BICESTERBUG

Submissions On Design of Banbury Road Roundabout, Bicester

03 April 2021

Figure 1: Bidirectional Cyclops Design showing give way markings at points of potential conflict.

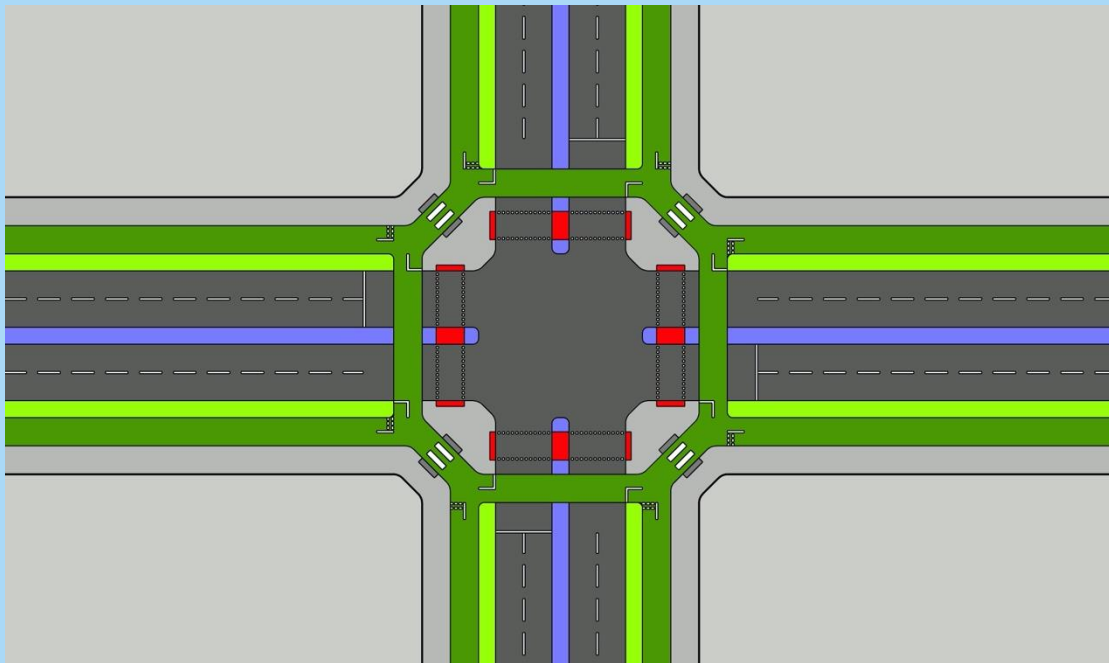
One notable issue with the design is the unidirectional nature of the circulatory carriageway for cyclists. This inevitably leads to delay for both cyclists and motor vehicle users and thereby reduces capacity as cyclists will need to travel across more limbs of the junction than pedestrians. However, unidirectional movements are not an essential element of Cyclops style junctions. Bidirectional movements are possible on such junctions such as in the Netherlands, and one of the designers of the UK variant of Cyclops junctions Richard Butler, the Engineering Manager for Transport for Greater Manchester has confirmed that the Cyclops design supports bi-directional travel (personal correspondence, 2021). In the Netherlands, similar junctions support bi-directional cycle travel. One issue is managing the priorities at conflict points, but this could be achieved on a 4-arm intersection with 4 simple give way points (see Figure 1 below).
